Change Order #10

Regional Linear Park Phase II (Hike & Bike Trail)

Project: Regional Linear Park Phase II
Project#: STP 2019 (086) TP
Contract: C-18-199-02-12
CSJ: 0921-02-409
Limits: Hall Acres to Ridge Road

CONSTRUCTION CONTRACT CHANGE ORDER NUMBER: 10

14a

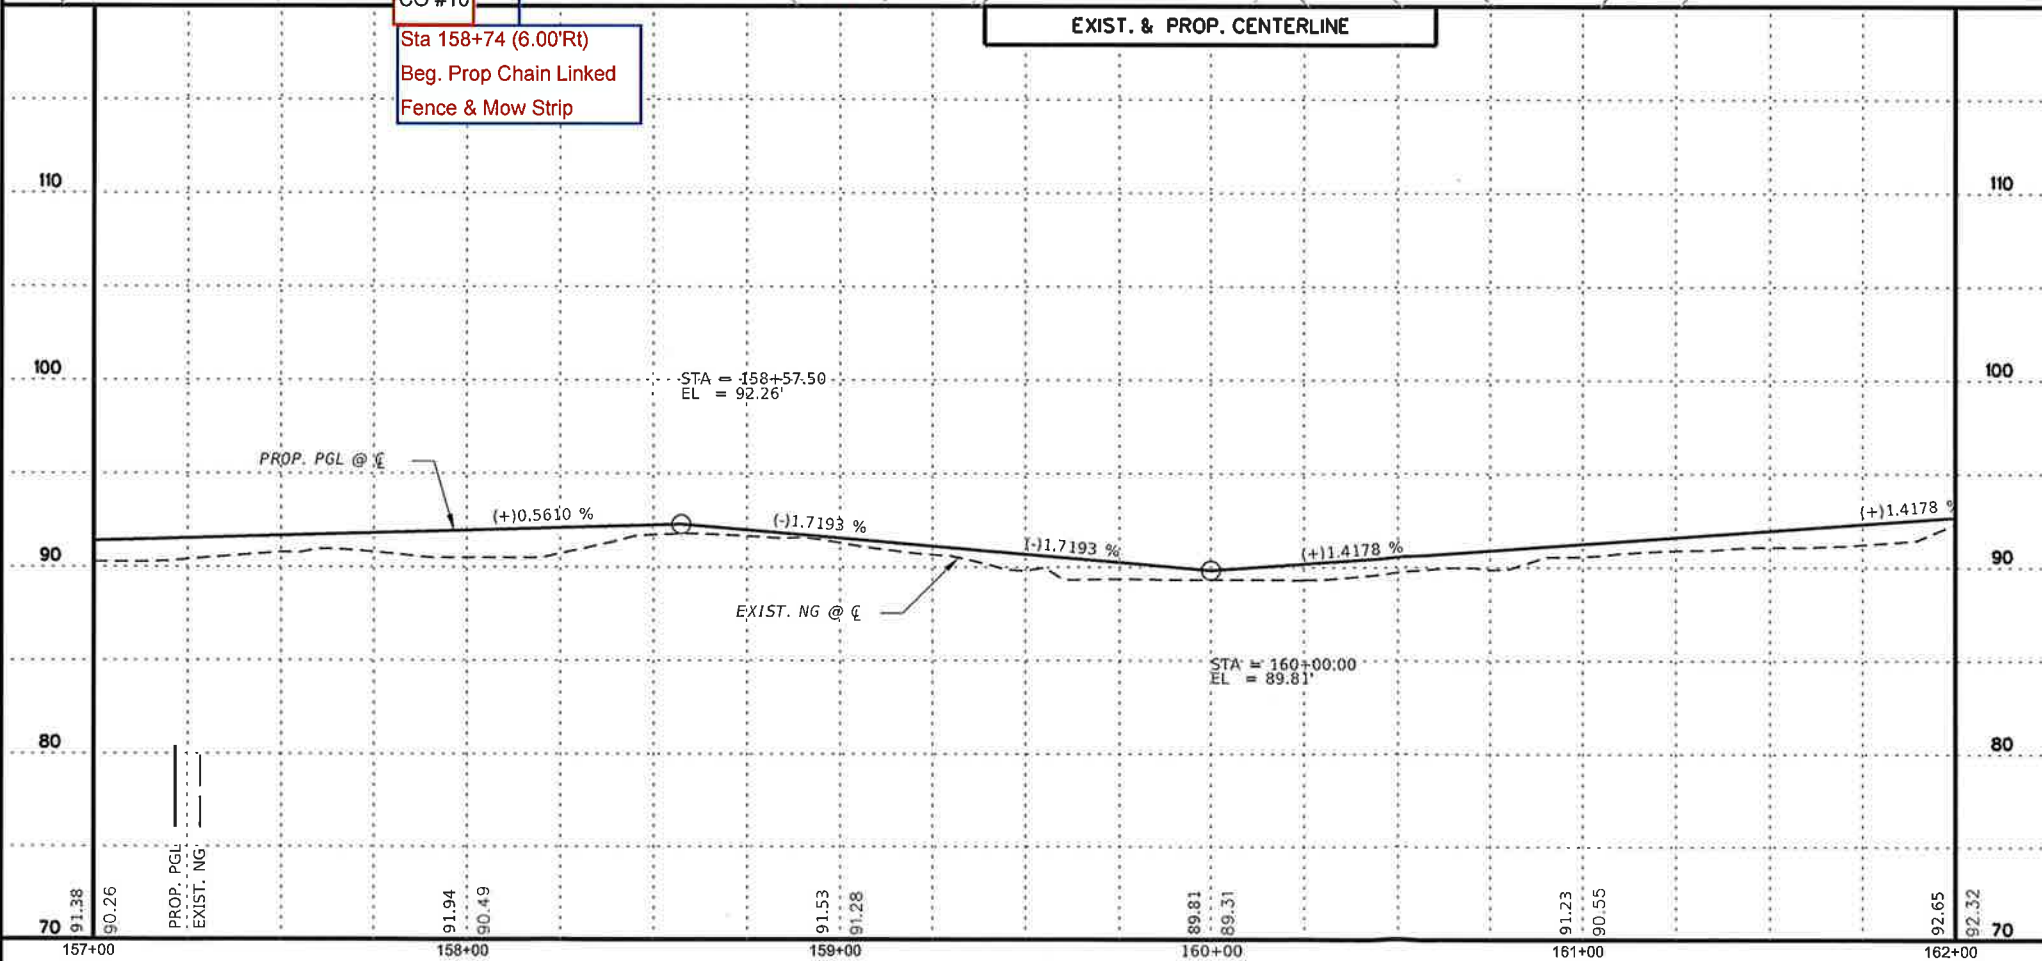
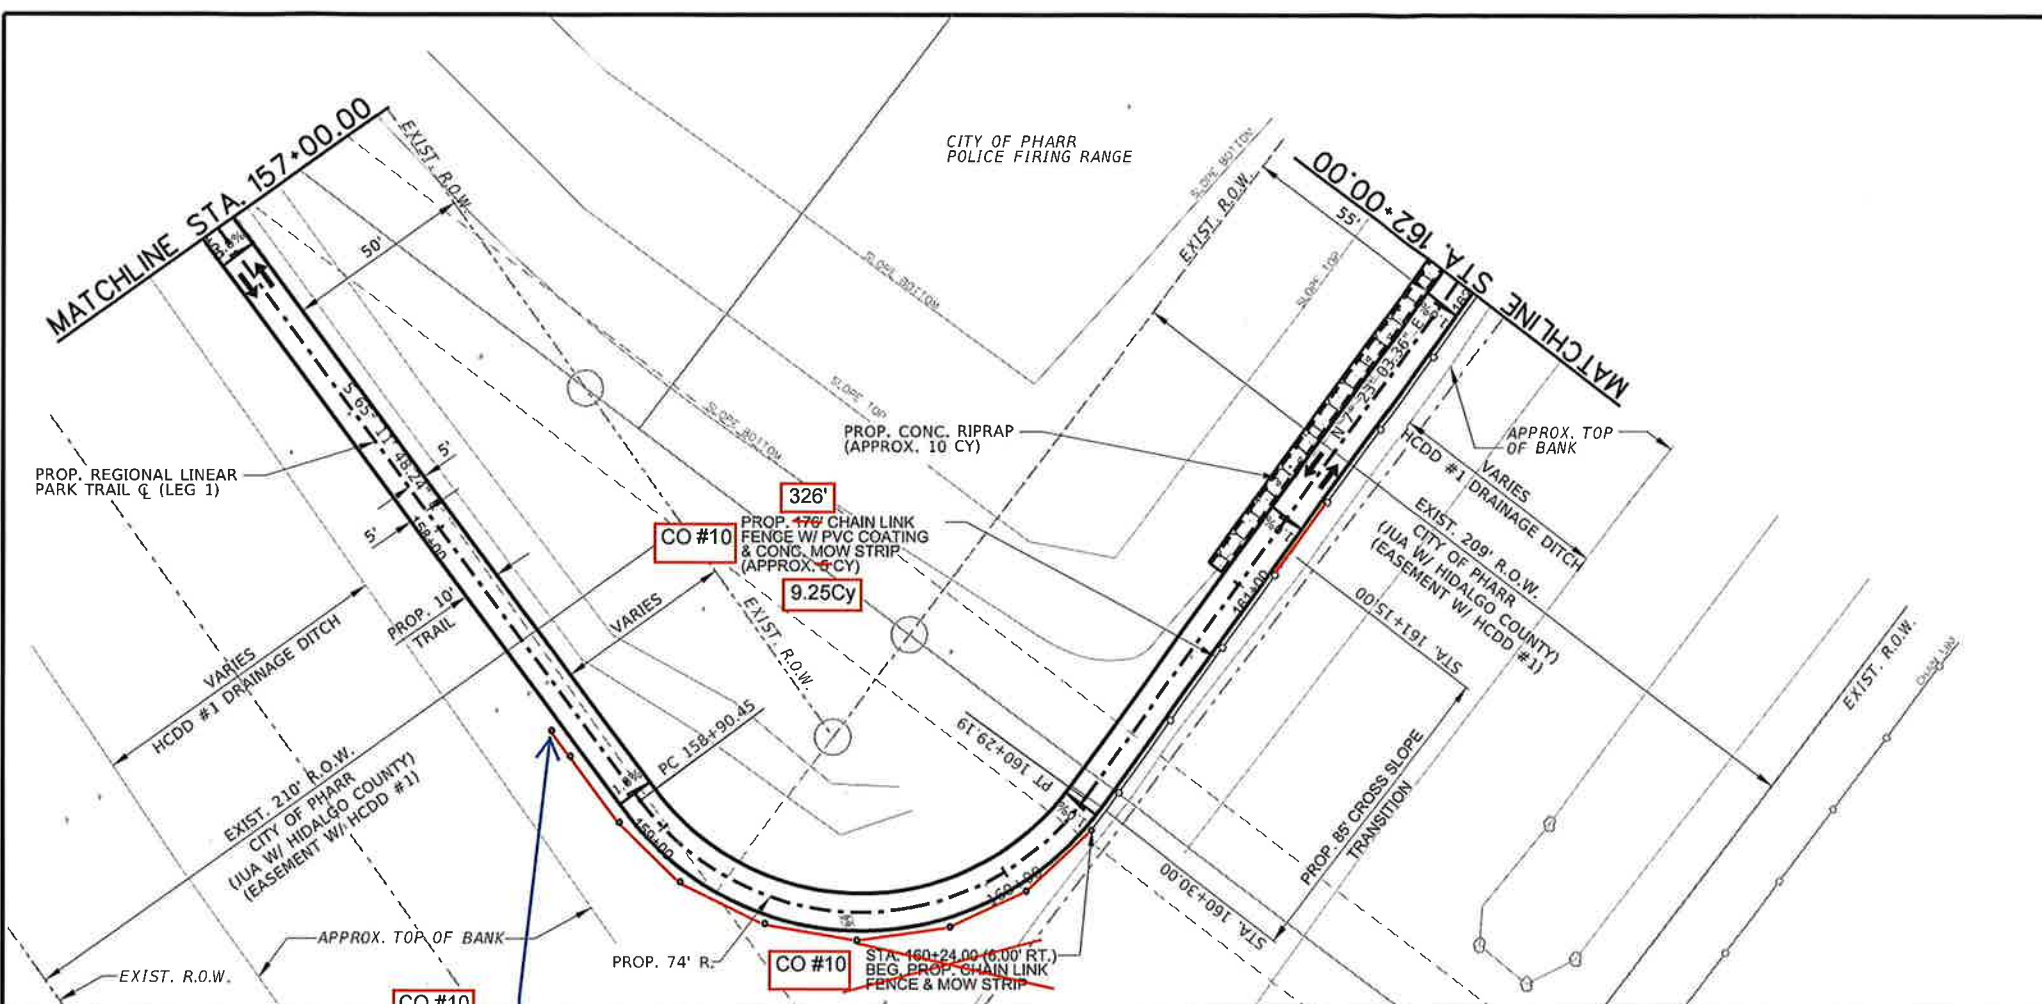
SHEET SUMMARY			
ITEM	DESCRIPTION	UNIT	QUANTITY
432	RIPRAP CONC. (4")	CY	10
432	RIPRAP CONC. (4") (MOW STRIP)	CY	5
550	CHAIN LINK FENCE (INSTALL)16'	LF	176
CO #10		9.25Cy	326Ft

CO #10 - Change Order #10
Add Ch Linked Fence & Mow Strip
 Add MBGF, GET, DAT & Mow Strip
 Add Luminaire Drill Shaft
 Add Luminaire Wiring

CHK: DWS	DES: TC	APP: TC	DATE: 8/23/18
STATE: TEXAS	COUNTY: HIDALGO	PROJECT NO.: STP 2019 (086) TP	SHEET NO.: 64a
SECTION NO.: 0921	SECTION NO.: 02	JOB NO.: 409	HIGHWAY NO.: RLPP

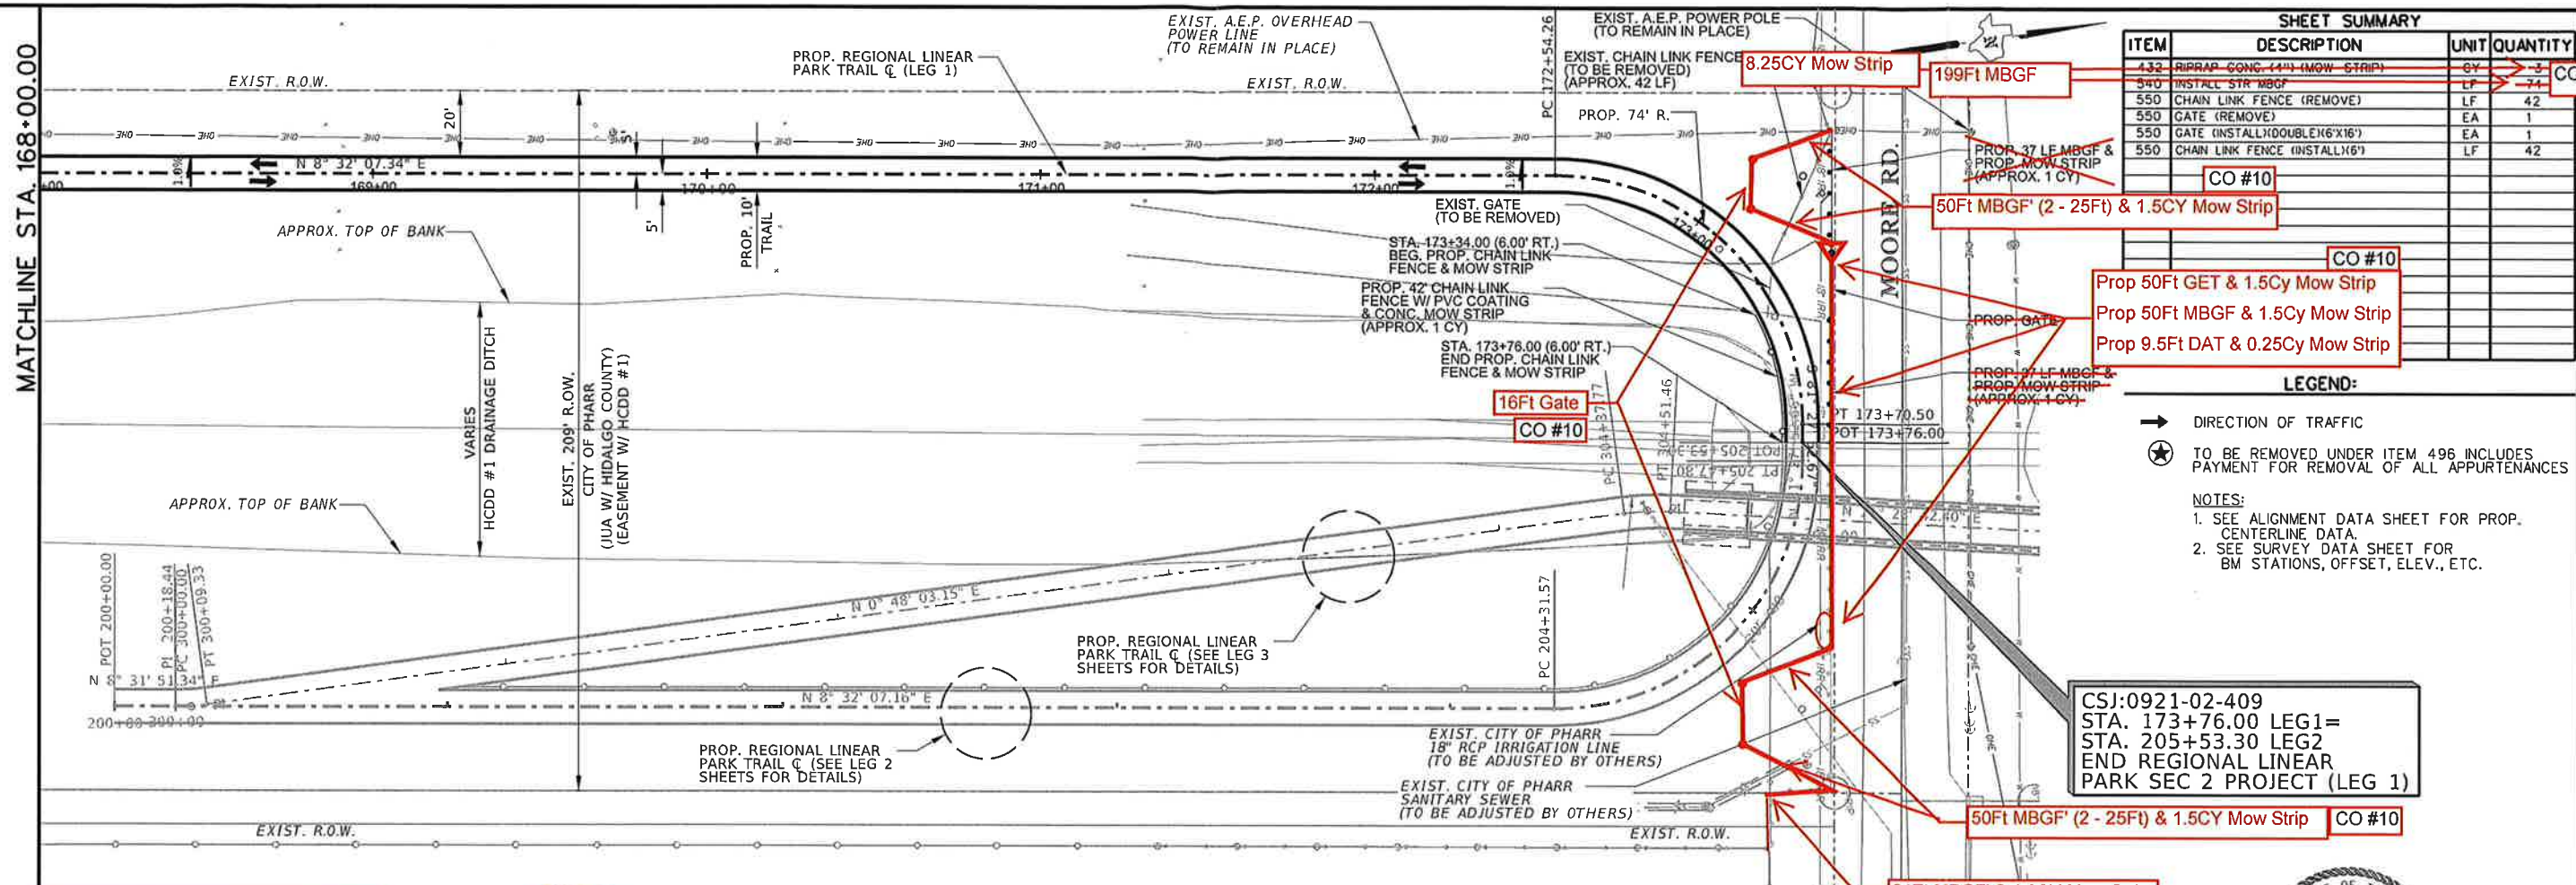
SHEET SUMMARY			
ITEM	DESCRIPTION	UNIT	QUANTITY
432	RIPRAP CONC. (4") (MOW STRIP)	CY	3
540	INSTALL STR MBGF	LF	74
550	CHAIN LINK FENCE (REMOVE)	LF	42
550	GATE (REMOVE)	EA	1
550	GATE (INSTALL) (DOUBLE) (6'X16')	EA	1
550	CHAIN LINK FENCE (INSTALL) (6')	LF	42

66a

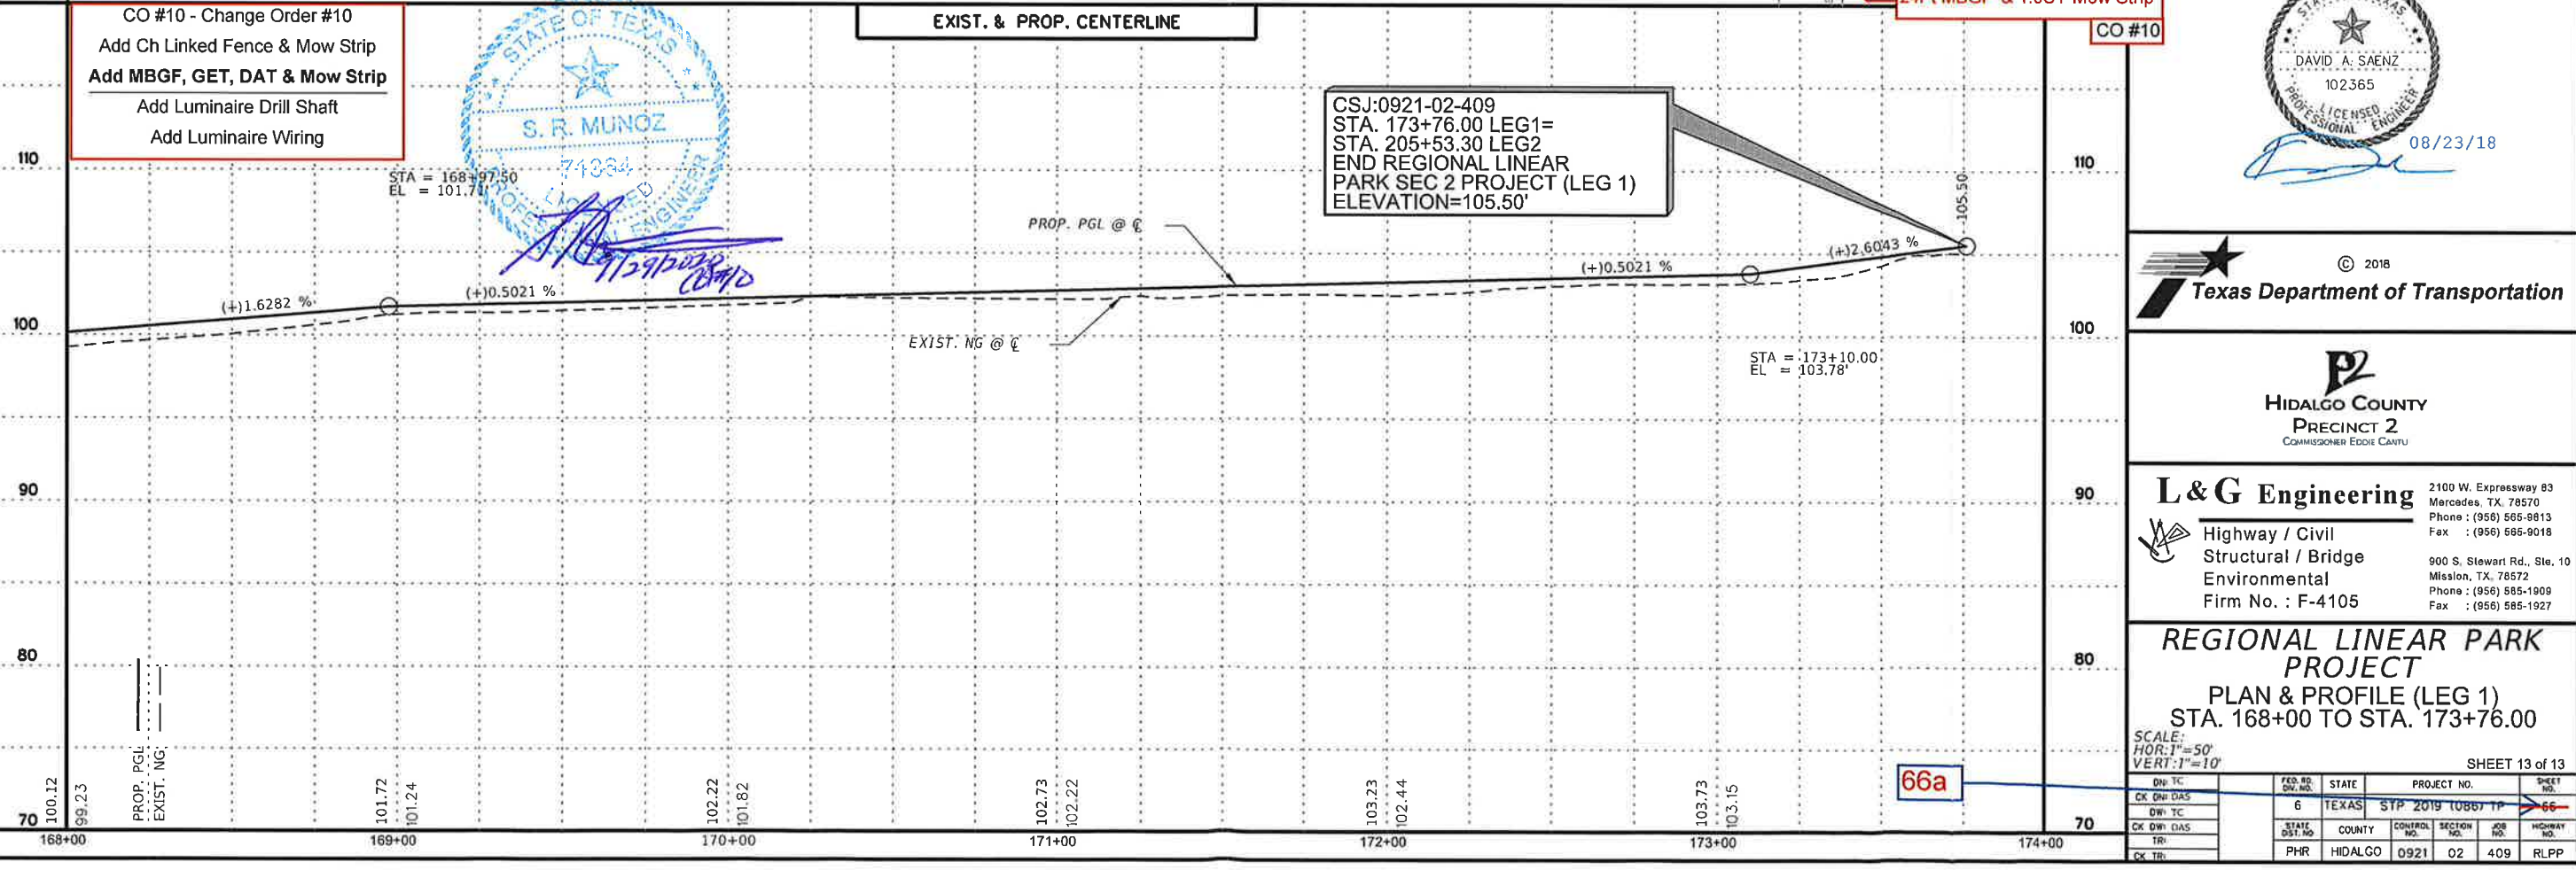
CO #10 - Change Order #10
 Add Ch Linked Fence & Mow Strip
 Add MBGF, GET, DAT & Mow Strip
 Add Luminaire Drill Shaft
 Add Luminaire Wiring
